Item H-5

Consider a resolution approving a Site Plan Amendment with Variances for Landscape Systems on approximately 17.52 acres, legally described as Tract 1D01B and Tract 1D01A1 of the John Martin Survey, Abstract 1153 (account # 42818999 and 42819014), a portion of Lot 7, Block 1, Pearson Crossing, and Tract 1F, Abstract 1153 (account #: 04069838) of the John Martin Survey, and addressed as 1816 Johnson Road, 1850 Pearson Crossing, 1908 Pearson Crossing, and 1863 Keller Parkway. Ed Ruibal, Landscape Systems, Applicant/Owner; Don Dinger, Owner. James Neill, Owner. (SP-22-0033)

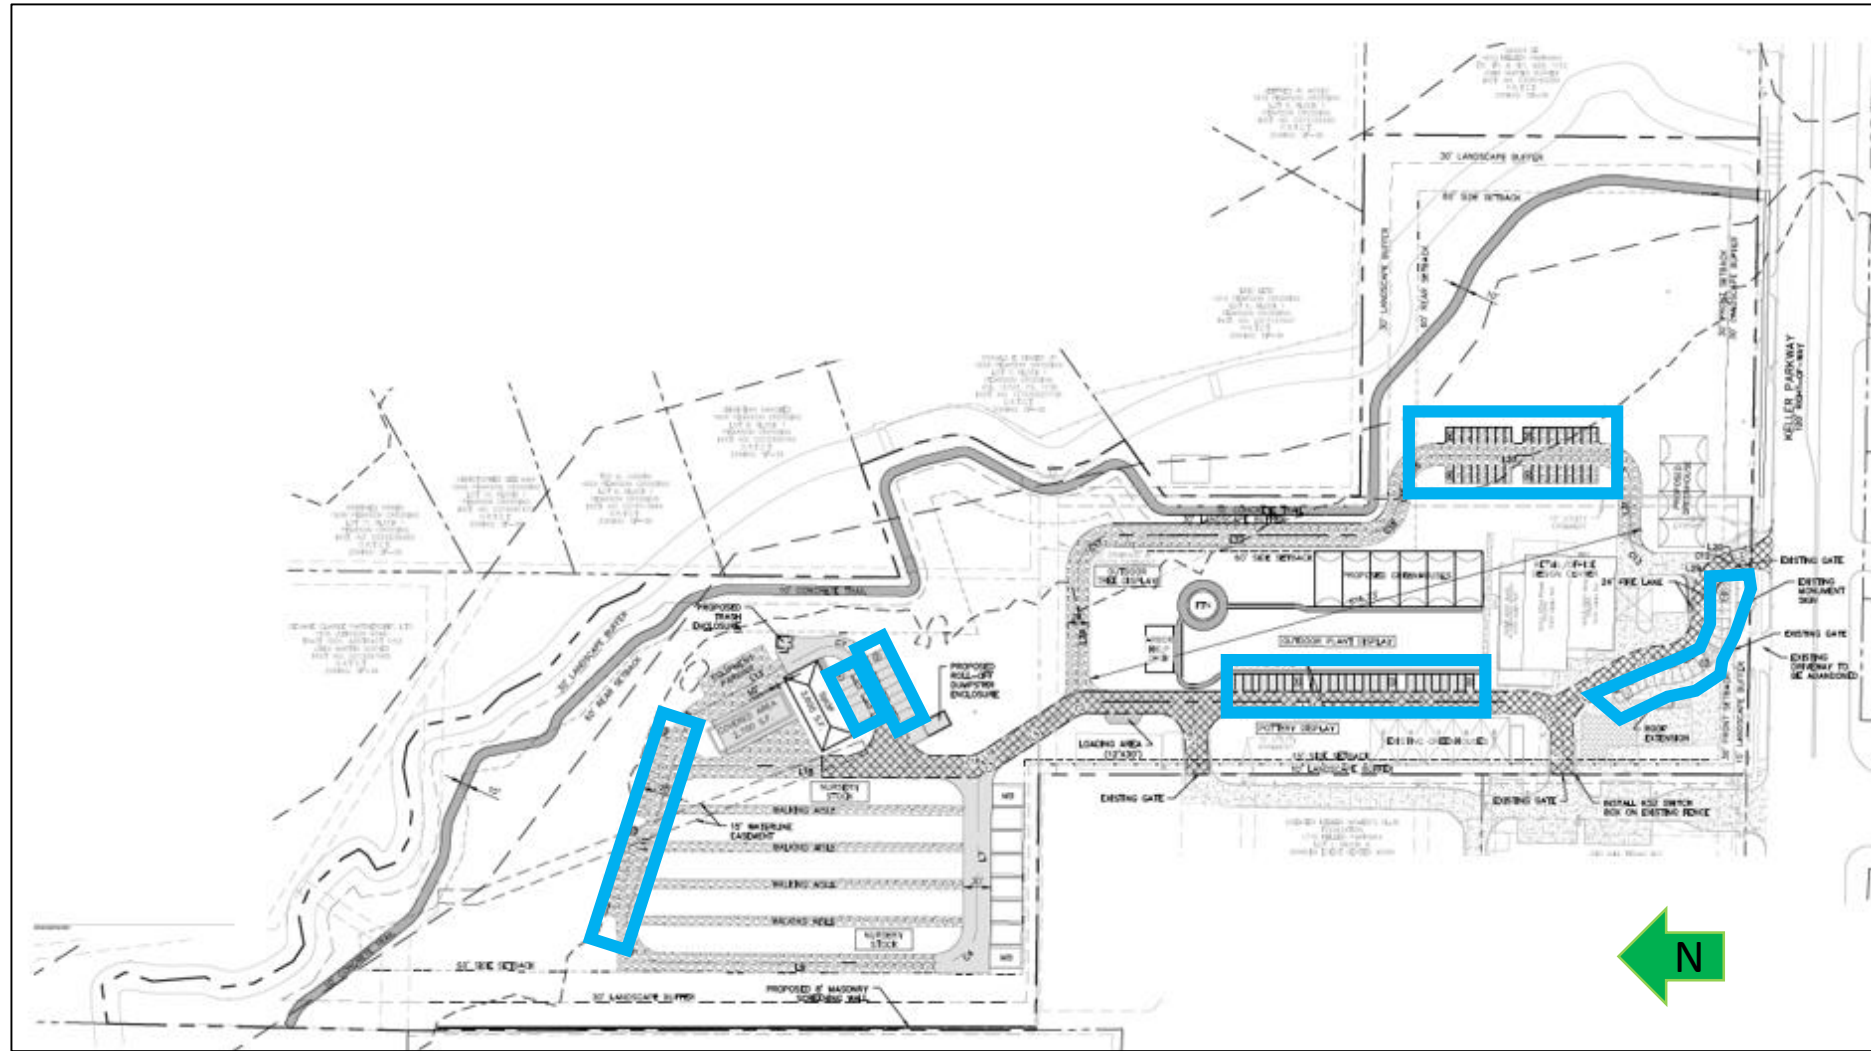
The applicant provided **preliminary** utility and drainage plans to the City supporting this application. More detailed utility and drainage plans will be reviewed with the final plat and civil engineering plans at a later date.

The City-Wide Trail System Master Plan indicates a significant trail connection through the property that will nearly close the gap between Keller Parkway and Johnson Road. The trail is required to be constructed at the same time as the proposed development.

A 6-foot sidewalk will be required to be installed along 1863 Keller Parkway east of the existing 5-foot sidewalk.

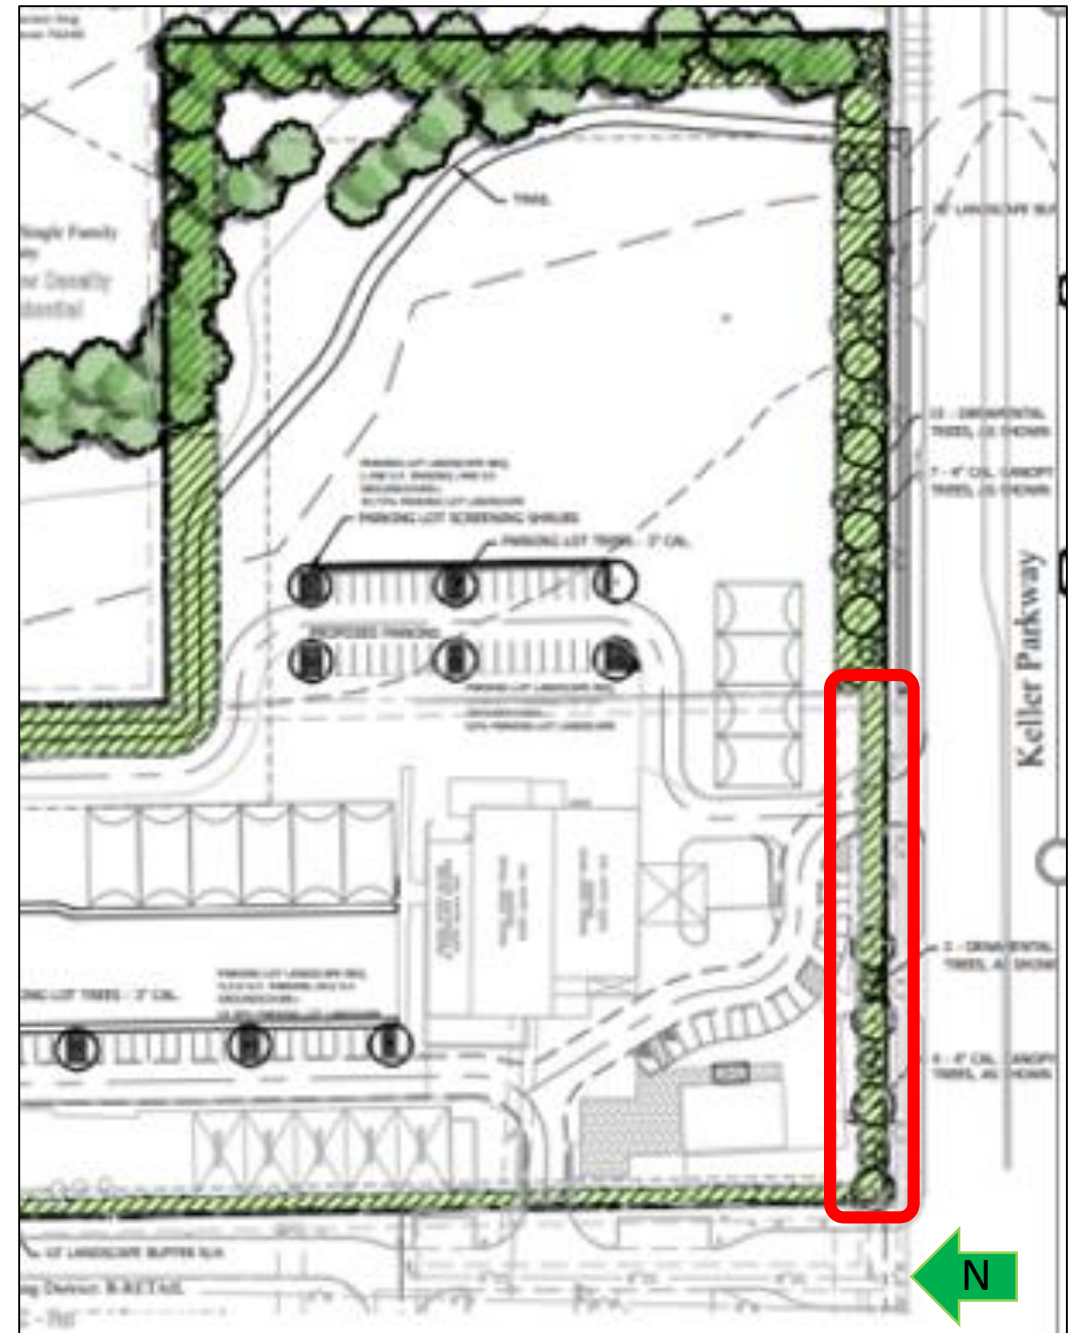
UDC Section 8.08 (F)(1) requires a 30' landscape buffer on Keller Parkway, a major thoroughfare as identified on the Master Thoroughfare Plan.

- To allow the existing 15' landscape buffer to remain for approximately 300' on the southwest portion of the subject property adjacent to Keller Parkway rather than installing the 30' buffer required by the UDC.

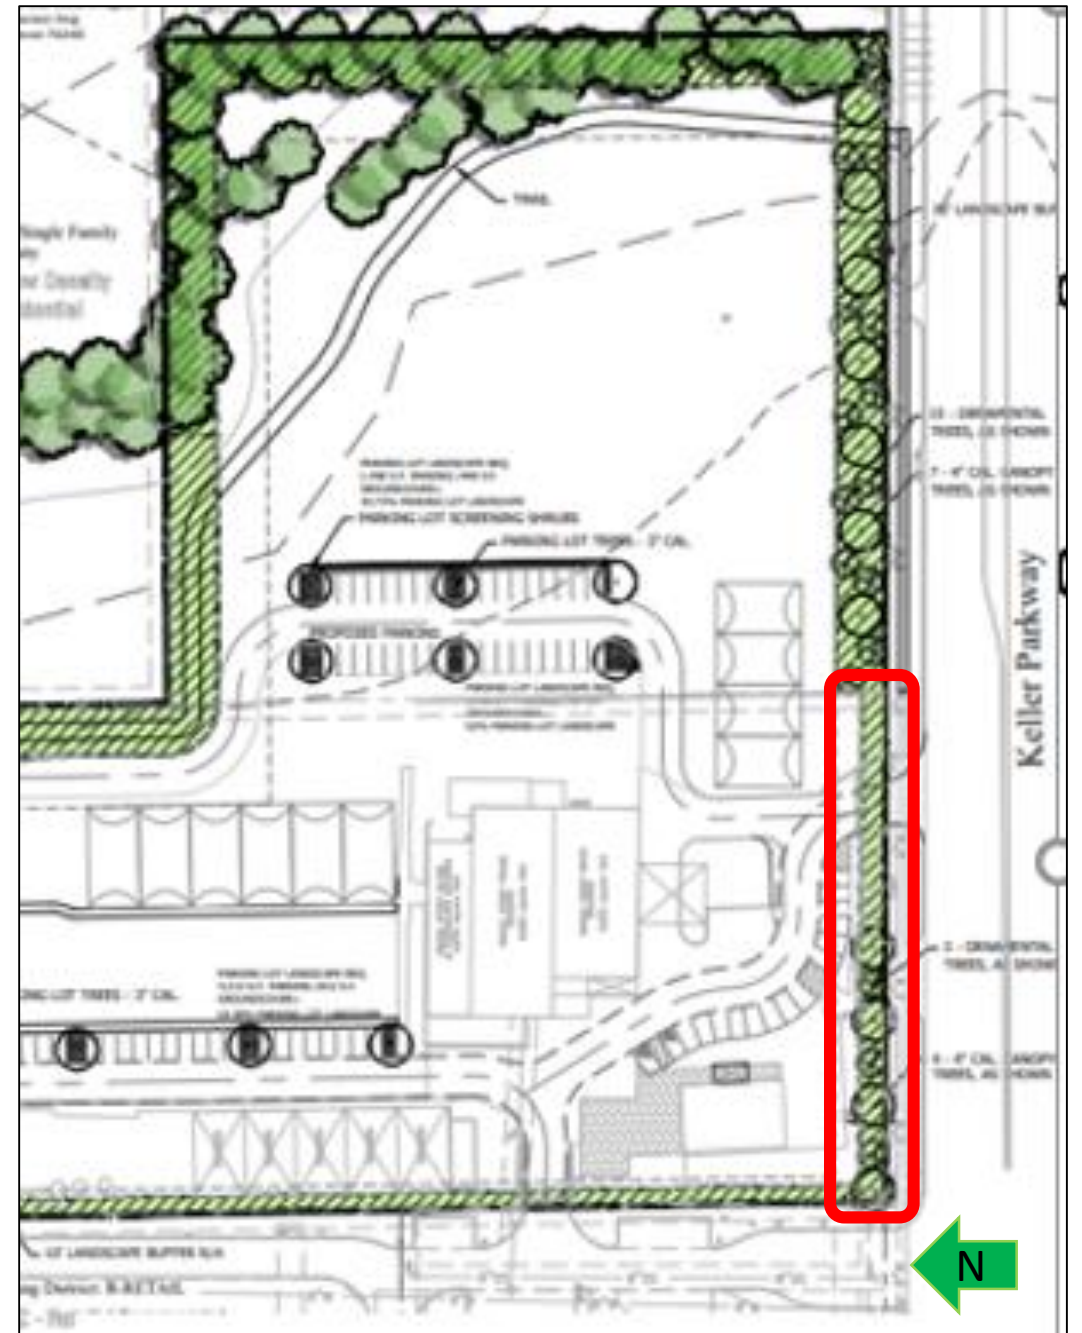
UDC Section 8.08 (F)(2) requires 4-inch caliper canopy trees spaced no more than 60' apart and two ornamental trees per 50 linear feet on Keller Parkway.

- To permit existing landscaping within the 15' landscape buffer to suffice without the required UDC plantings for 300' on the southwest portion of the subject property along Keller Parkway.

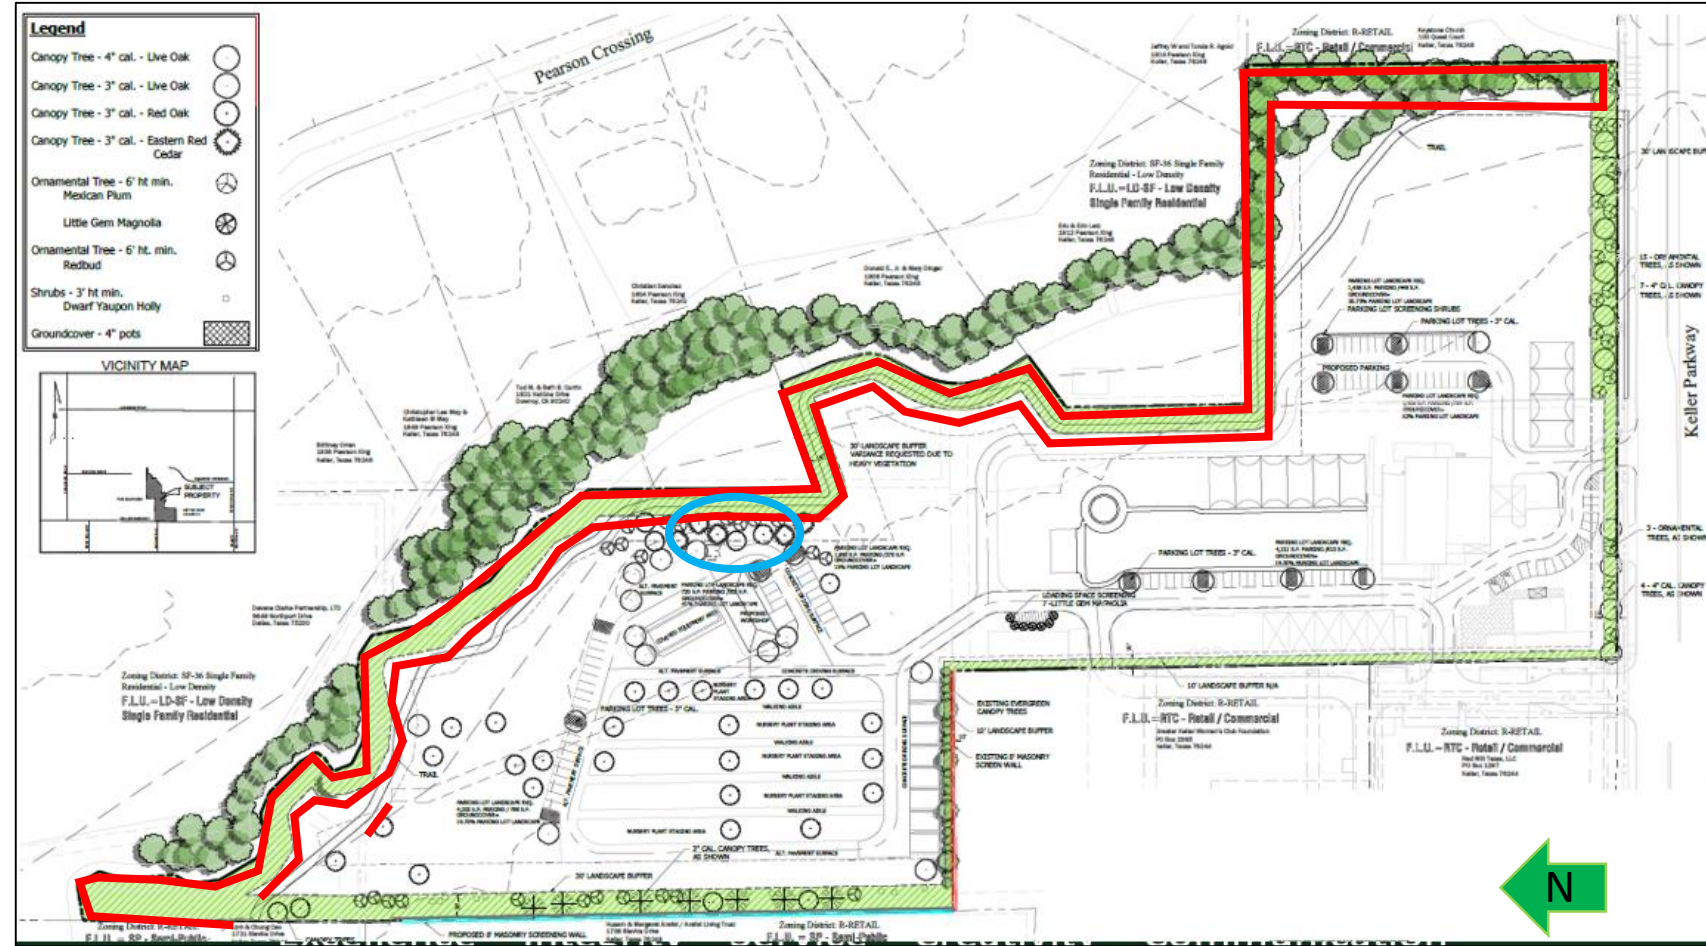
UDC Section 8.08 (F)(2)(c) requires 3-inch caliper canopy trees spaced no more than 60' adjacent to residential properties.

The Applicant requests to allow the existing floodway/floodplain riparian habitat to act as the buffer and not add any additional trees along the north and east property lines. This area has a variable width of 150'.

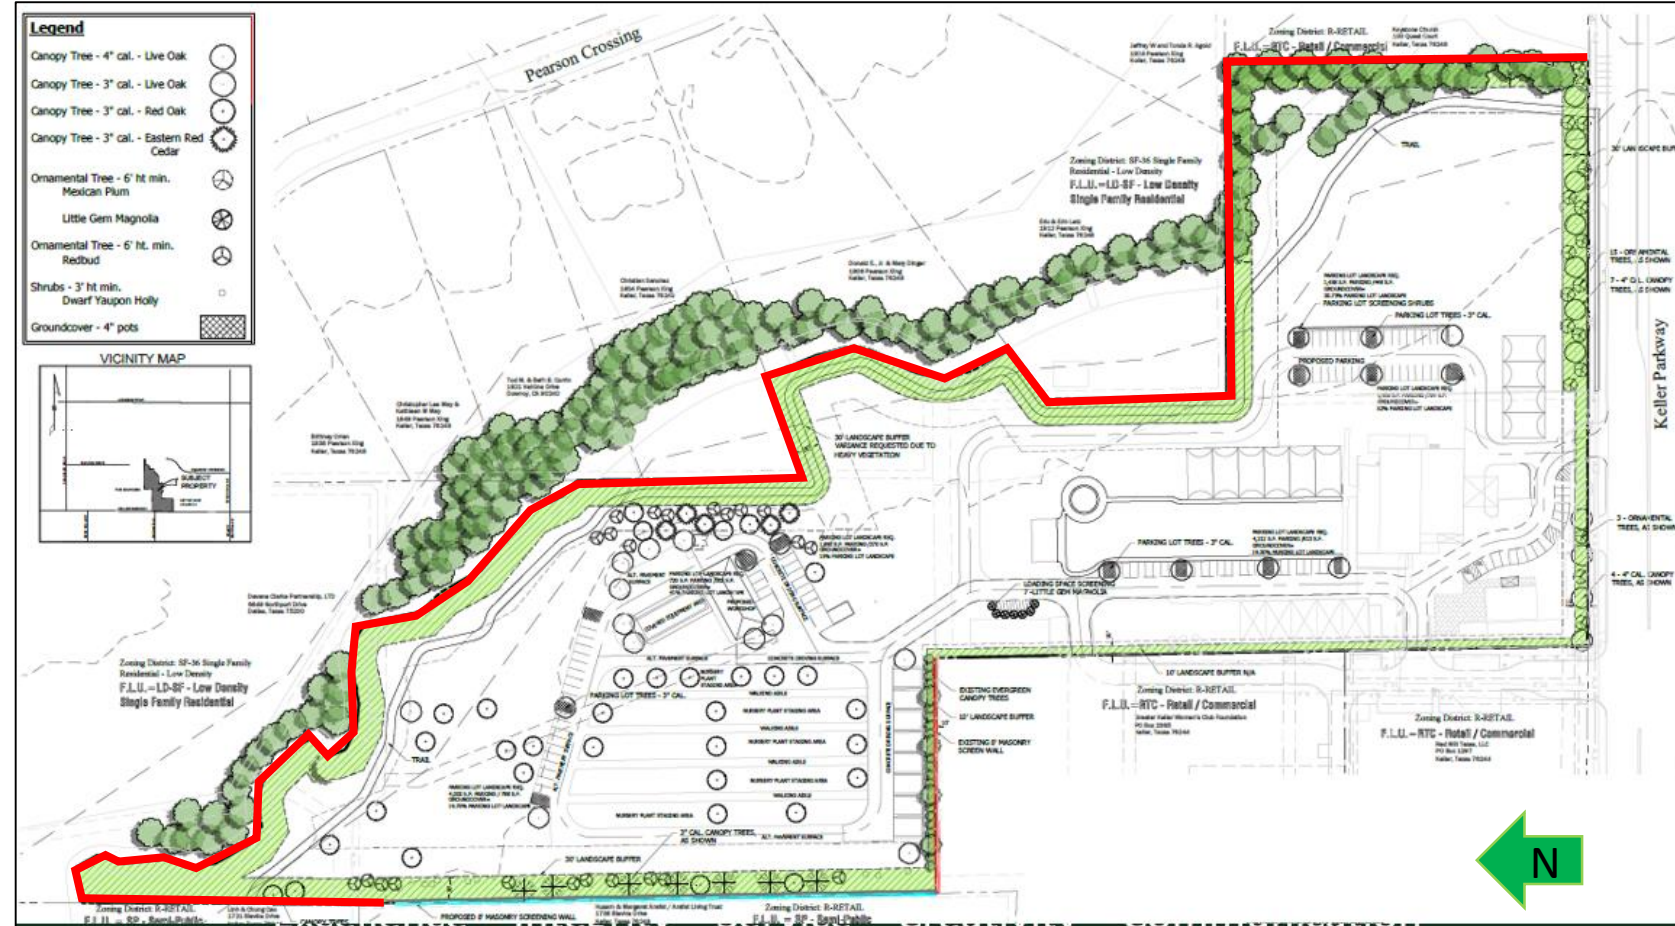
UDC section 8.13 requires a screening wall adjacent to a single-family use or zoning district.

The Applicant proposes to construct an 8' tall screening wall adjacent to 1738 Blevins Lane. Variances are requested for the north and east property lines, because a screening wall cannot be constructed in the floodplain/floodway. The riparian habitat would act as the buffer.
